December 17, 2019

Re: New Jersey Department of Environment of Protection (NJDEP) CSTAG/NRRB Stakeholder Letter (dated November 14, 2019) and November 20 Stakeholder Presentation - Lower Passaic River Study (LPRSA), Diamond Alkali Superfund Site, Administrative Settlement Agreement and Order on Consent for Remedial Investigation/Feasibility Study CERCLA Docket No. 02-2007-2009

CPG Response to NJDEP CSTAG/NRRB Statement December 17, 2019 Page 5 of 12

Attachment 1: Figures 3a and 3b from CPG CSTAG/NRRB Statement, November 12, 2019

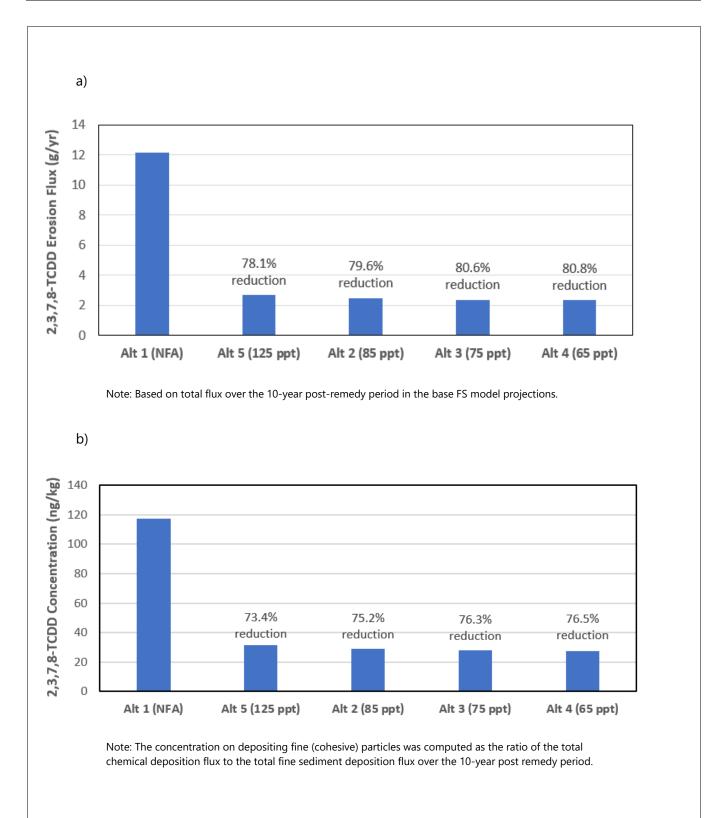
The NJDEP argues against the multiplier by asserting there is considerable uncertainty in identifying whether a location is vulnerable to erosion because of "often-unpredictable shifting of erosional and depositional areas of the river." NJDEP has inaccurately characterized our understanding of erosion and deposition. Knowledge of river hydrodynamics, geomorphology and sediment transport provides a basis to identify areas vulnerable to erosion. Bathymetric differencing of multibeam surfaces provides empirical evidence of where erosion of 3 inches or more has occurred. The utility of bathymetric changes to identify areas subject erosion underlies USEPA's directive to collect such data, which resulted in a bank-to-bank bathymetry survey in 2019. The combination of a fundamental scientific understanding of erosion and deposition and the findings from bathymetric differencing provide a strong basis to identify areas vulnerable to erosion.
